Work Order ID 106196

Item Name: LOWER CUTTER ASSY

APICAL INDUSTRIES, INC.	ENGINEERING CHANGE NOTIC NO. 03526				SHEET OF 1	
	DWG NO. 649.4900	REV: A	PREPARED BY S. COCHRAN	DATE: 05-29-12	EFFECT ON DWG <input type="checkbox"/> INC. <input checked="" type="checkbox"/> UNINC.	
	DWG TITLE: CUTTER ASSY					
APPROVED BY: ENGR <i>[Signature]</i>		MFG <i>[Signature]</i>	QC <i>[Signature]</i>	EFFECT: CURRENT STOCK & NEXT ORDER		
TRANSACTION CODES (TC): A-ADD C-CREATE R-REVISE D-DELETE		REASON: REVISED INSPECTION DIMENSIONS

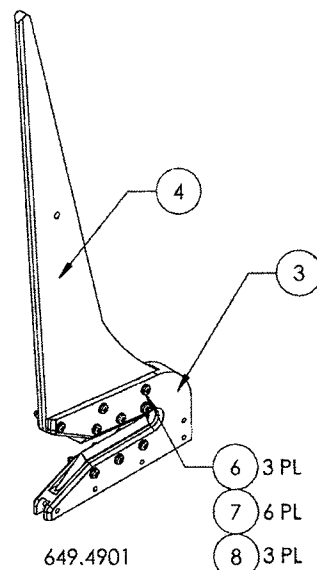
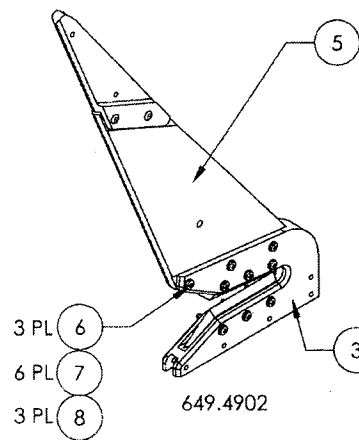
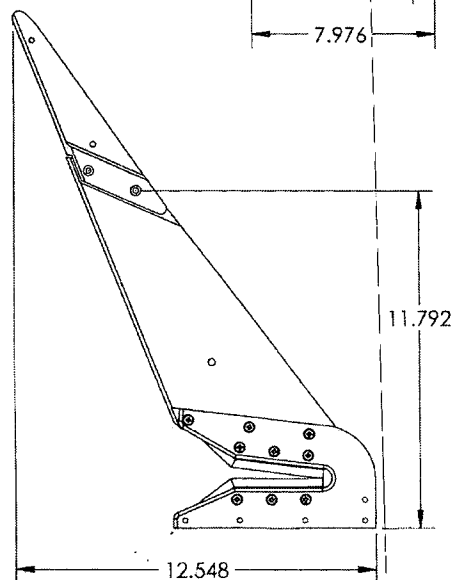
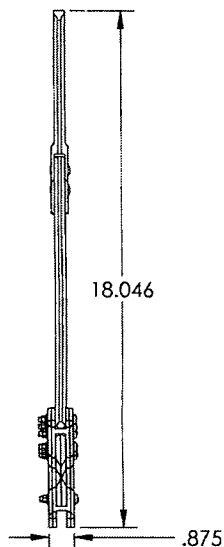
SHEET 1, ZONE D2 IS:

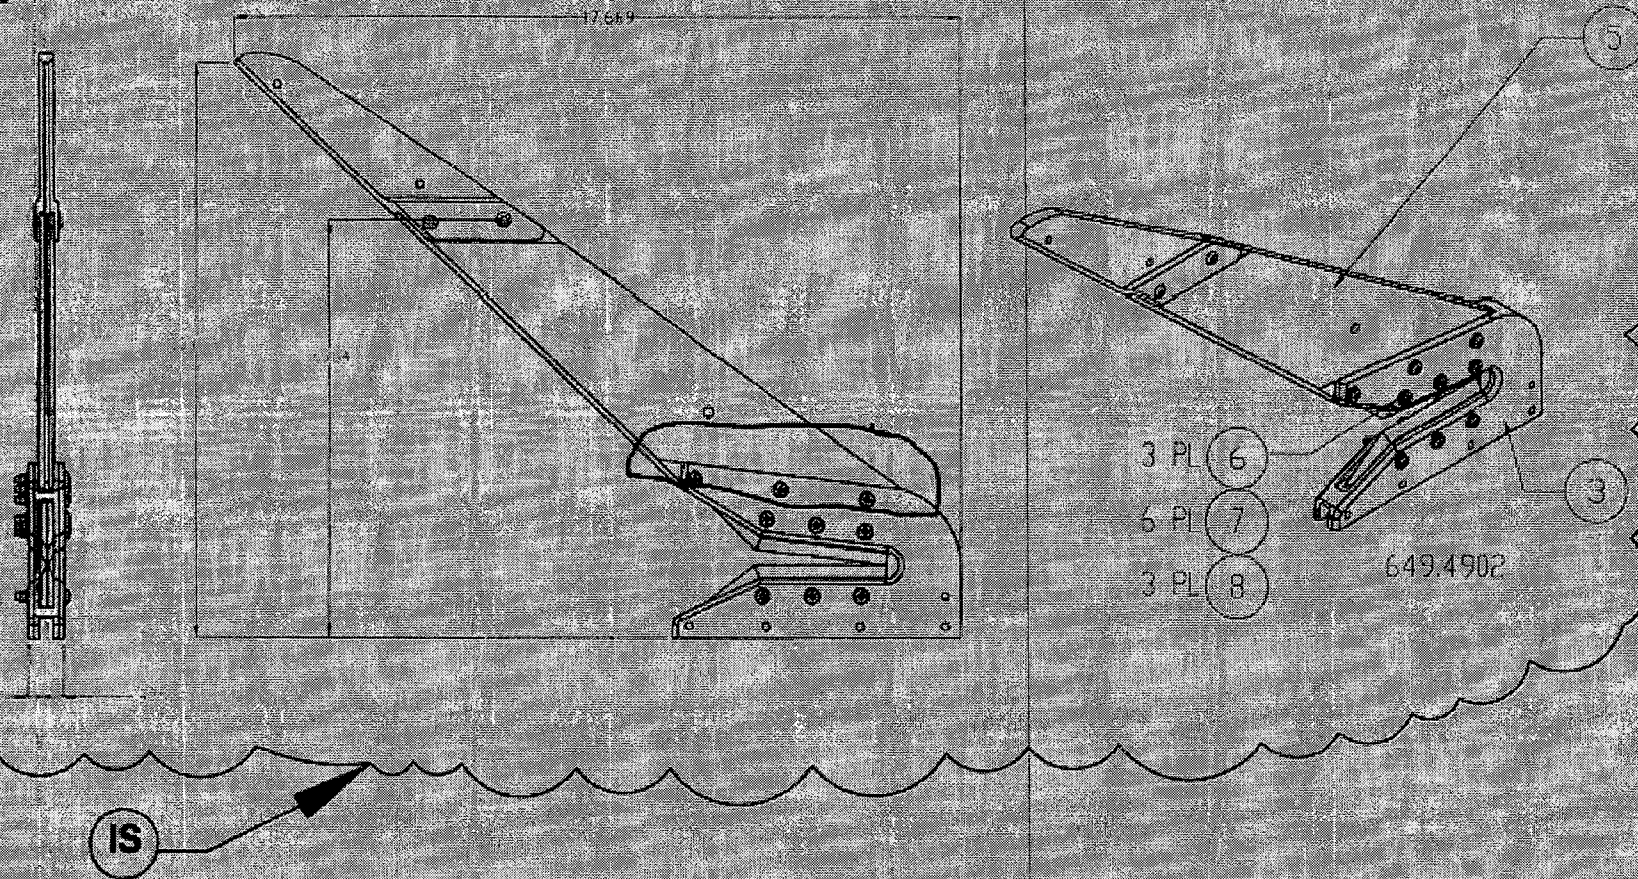
Hiya,
The drwg does not call up for RTV loctite on all fayin surfaces as all the others do, should there not be some on this also ??

Yes, it should have RTV there as well.
